HISTORIC AND DESIGN REVIEW COMMISSION

December 19, 2018

HDRC CASE NO: 2018-533
COMMON NAME: 335 TRAIL
LEGAL DESCRIPTION: NCB 6078 BLK 2 LOTS 9 THRU 14 & 17 THRU 20
ZONING: MF-33, H, RIO-1
CITY COUNCIL DIST.: 1
DISTRICT: River Road Historic District
APPLICANT: Katie Bingham, AIA/Mark Odom Studio
OWNER: Robert Price
TYPE OF WORK: Construction of twenty-four, residential units
APPLICATION RECEIVED: October 12, 2018
60-DAY REVIEW: December 11, 2018 (Postponed by applicant)
REQUEST:

The applicant is requesting conceptual approval to construct twenty-four condominium units on the vacant lot located at 335 Trail. The property features lots that are located within the River Improvement Overlay only, as well as those that are located within both the River Improvement Overlay and the River Road Historic District. The applicant has proposed for the condominium units to feature three stories in height. Access to the site will be provided from Trail Street and Huisache Street.

TRL : Setbacks

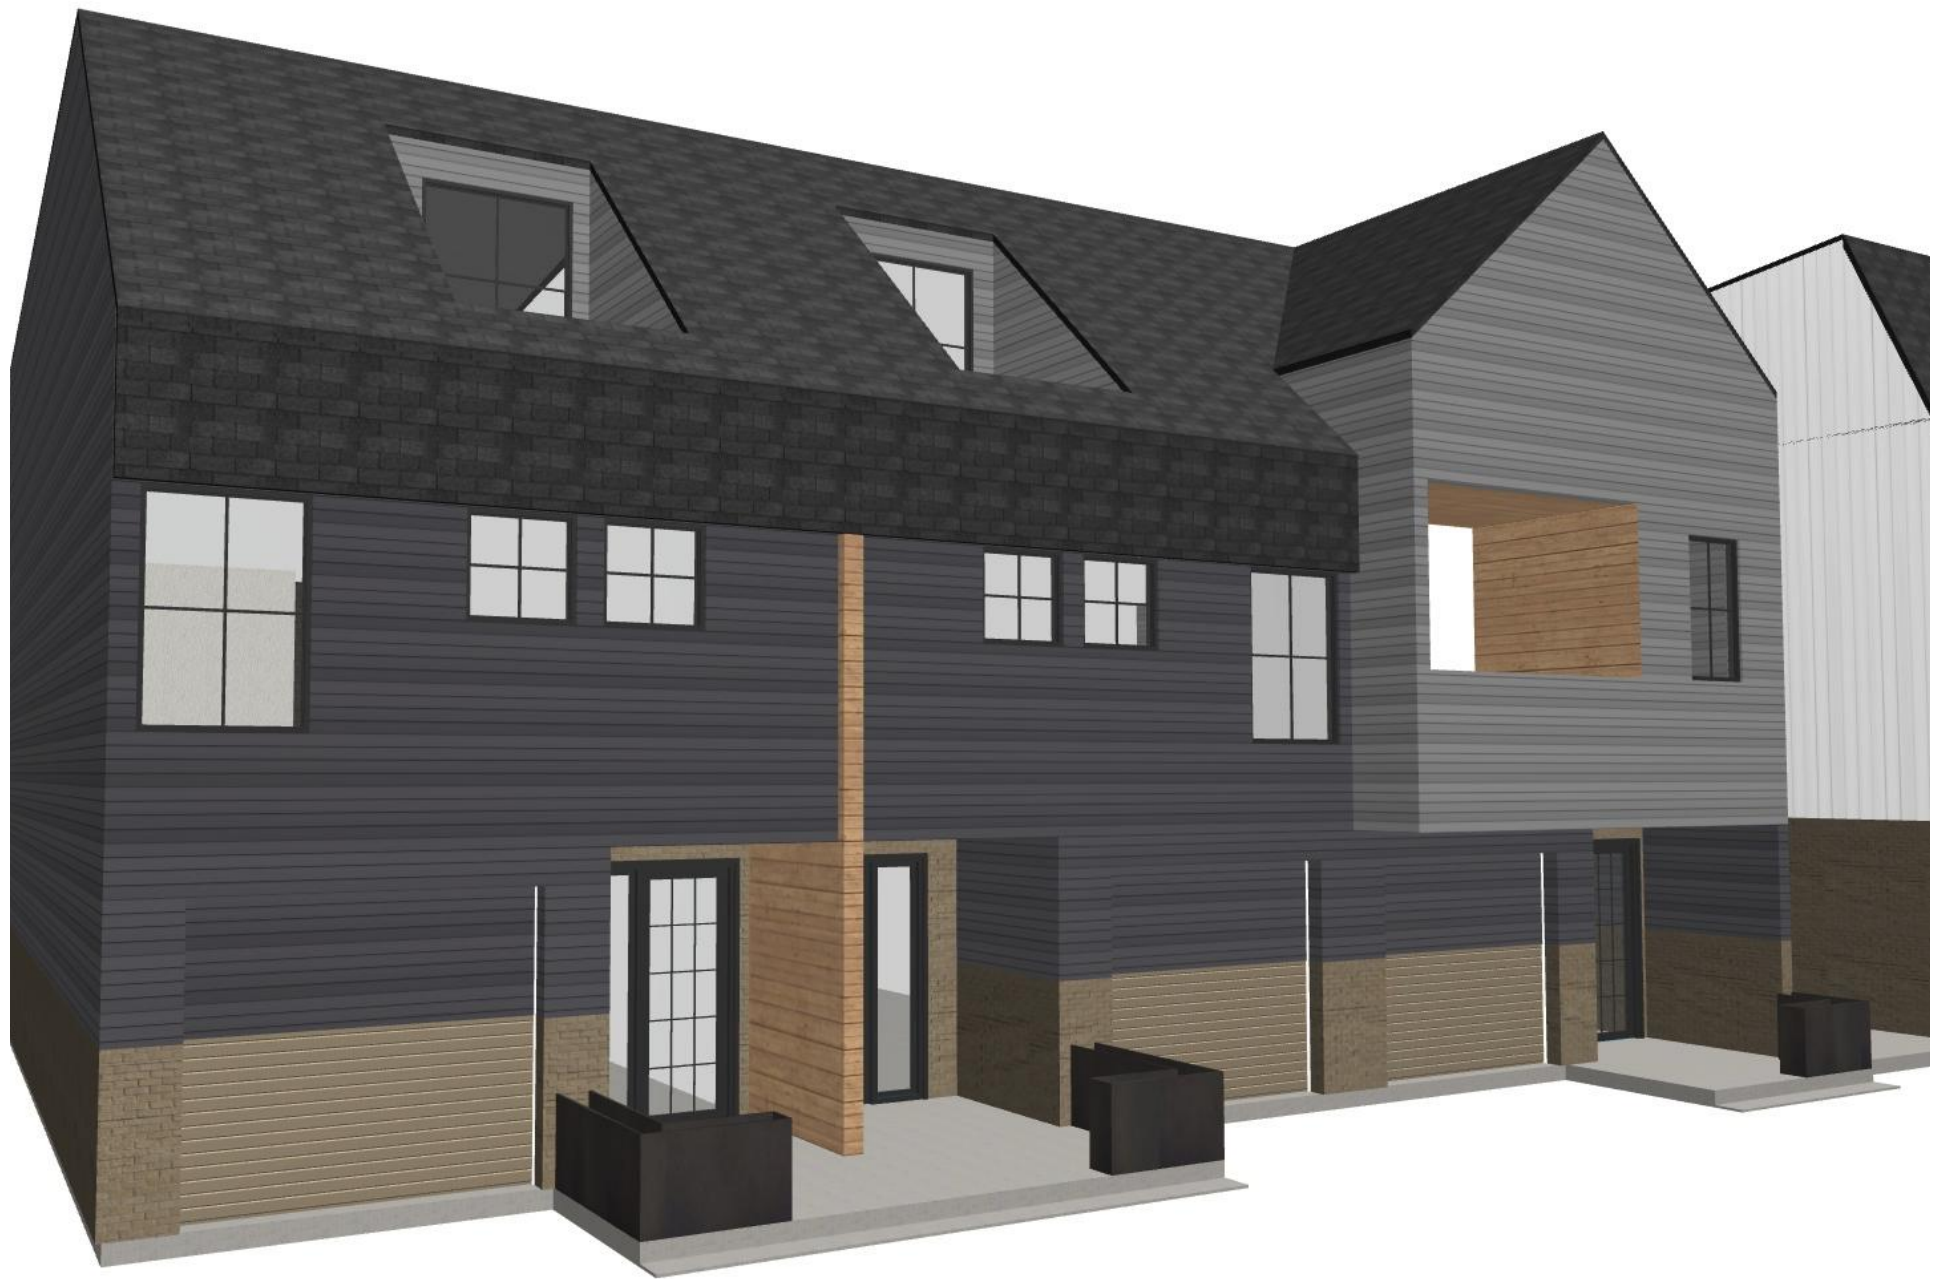
- g. **SETBACKS** – Both the UDC Section 35-672(b)(A) and the Guidelines for New Construction note that front facades on new construction are to align with the front facades of adjacent buildings where a consistent setback has been established along the street frontage. On Trail, the applicant has proposed a setback that per the submitted site plan features setbacks that are appropriate; however, on Huisache, the applicant has proposed setbacks that are less than those of the existing structures on Huisache. To mitigate, the applicant has proposed for the westernmost structure to feature a setback that matches that of the structure to the west. Staff finds that the applicant should incorporate additional setback depth on Huisache. Setbacks should be consistent throughout the development and consistent with the existing setbacks on the block.

- **Buffer:** Removing balconies from the 3rd floor of Trail Street Units (to retain privacy for neighbors)
- **Buffer:** We've pushed back the three (3) western units on Trail Street 20'-0" from the street and the remaining five (5) units 15'-0" from the street. This is to provide an large front yard which will be filled with trees and vegetation.
